Diane Conklin  
Spokesperson  
Mussey Grade Road Alliance  
PO Box 683  
Ramona, CA 92065

Tony Marino, Deputy Director  
Office of Energy Infrastructure Safety  
715 P Street, 20th Floor  
Sacramento, CA 95814

**RE: MUSSEY GRADE ROAD ALLIANCE COMMENTS ON THE R1 REVISION OF THE  
2026 TO 2028 UPDATE OF THE WILDFIRE MITIGATION PLANS OF SDG&E**

**Figure 2** - Count of circuit segments proposed for hardening mitigation in SDG&E's Appendix G in each HTM tranche for HFTD Tier 3.<sup>12</sup>

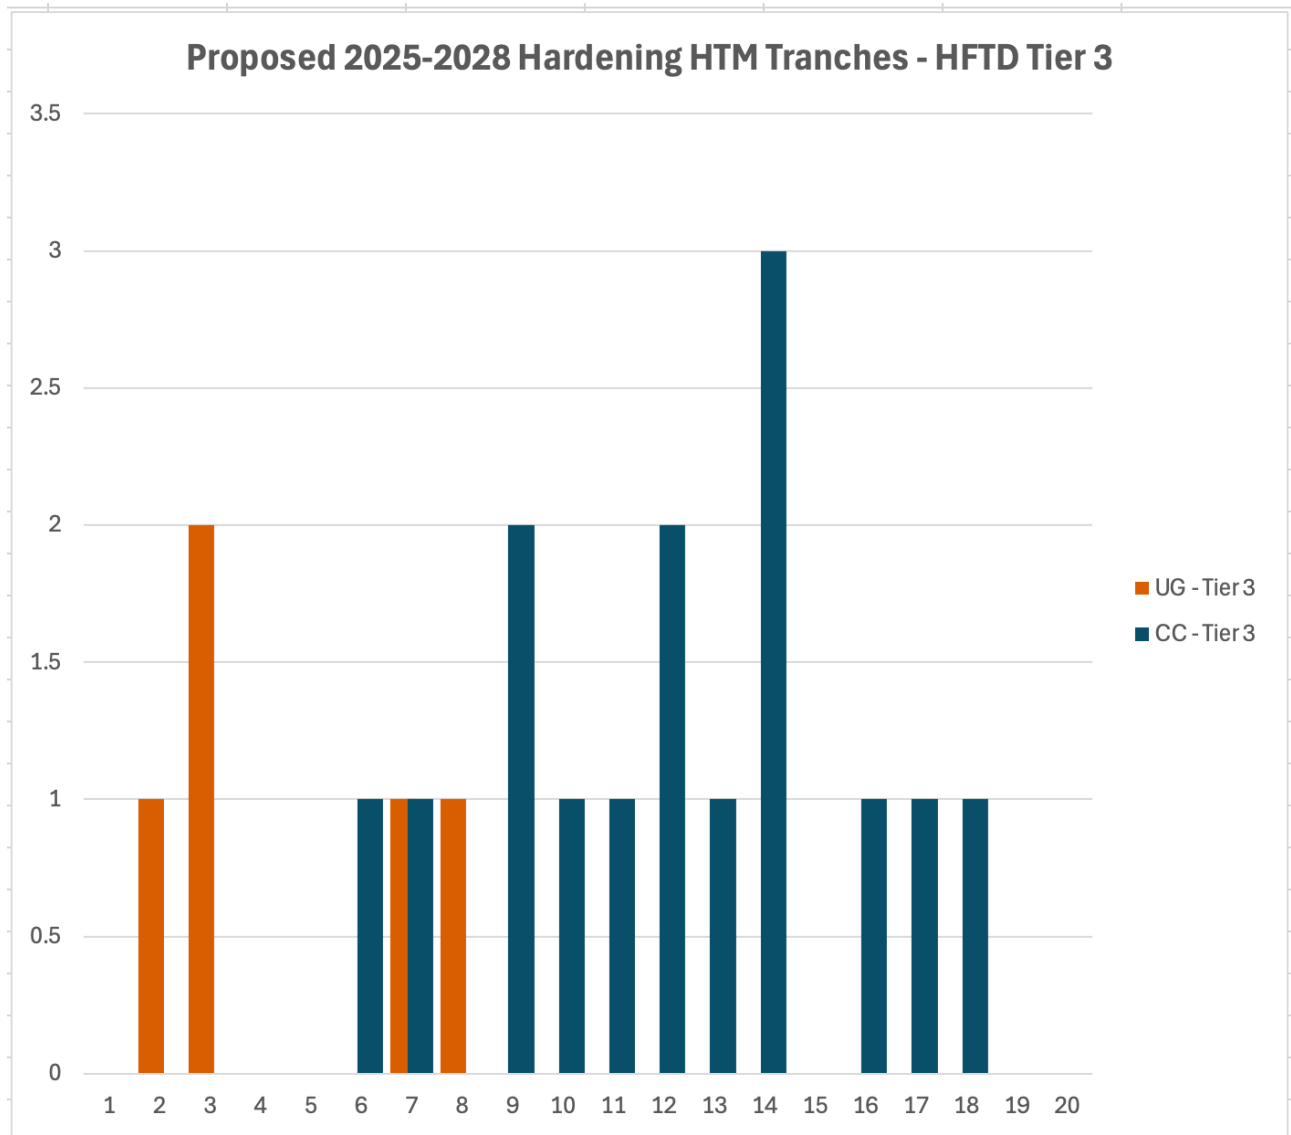
What becomes immediately apparent when using ordinal ranking of risk tranches is that SDG&E is assigning its highest risk tiers for undergrounding. This is confirmed by SDG&E's response to MGRA Data Request #7-1, which states that *"While the difference in mitigation effectiveness is close to 40%, SUG's application to higher-risk areas results in a greater risk reduction per mile."*

SDG&E's claimed motivation for this would likely be that because the circuits are higher risk they should be given the most effective mitigation. However, the impact of SDG&E's proposed

assignments is that these higher risk circuits are being left unmitigated until SDG&E obtains the funding and approval to mitigate them, likely 2028 at the earliest, leaving residents of the SDG&E service area exposed to potential ignitions from these high risk circuits in the meantime.

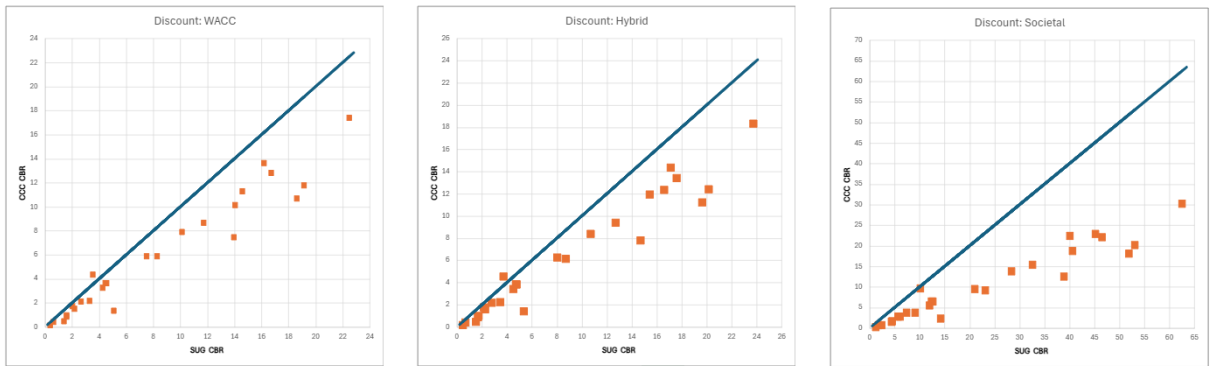
Assuming that SDG&E entries for 2026, 2027, and 2028 assume a certain set of proposed circuits for mitigation using SUG and CCC, swap the 50 miles of circuits planned for CCC mitigation in 2026 (CCC tab 17-20) with the 50 miles of circuits planned for undergrounding in 2028 (SUG tab 17-23). This is to test the sensitivity of the risk reduction result to the circuits being selected. Provide both Appendix G tabs for CCC and SUG and Table 8-1 entries for SUG and CCC:

These comparisons are available in Appendix G available at <https://www.sdge.com/2026-2028-wildfire-mitigation-plan>. The raw comparison between the two at the feeder segment level can be found in the tab “SUG\_vs\_CCC,” as well as tabs “SUG\_comp” and “CCC\_comp.” Visual representations of the compared CBRs can be found in the “SUG\_vs\_CCC\_plot” tab. There is one plot for each discount rate. Each orange square represents a feeder segment. The x axis measures the SUG CBR for the feeder segment, and the y axis measures the CCC CBR. The blue line denotes the point at which the SUG & CCC CBRs are equal. Points below the line indicate a higher SUG CBR and points above the line indicate a higher CCC CBR. These same resources can be found in the attached version of Appendix G that uses “NoAversion” risk attitude – as denoted in question 2. The plots can also be found below:

Each orange dot represents a Feeder-Segment CBR. Dots below the 1:1 ratio (Blue line) indicate that the SUG CBR is greater than the CCC CBR. Conversely, orange dots above the blue line indicate that the CCC CBR is greater than the SUG CBR.
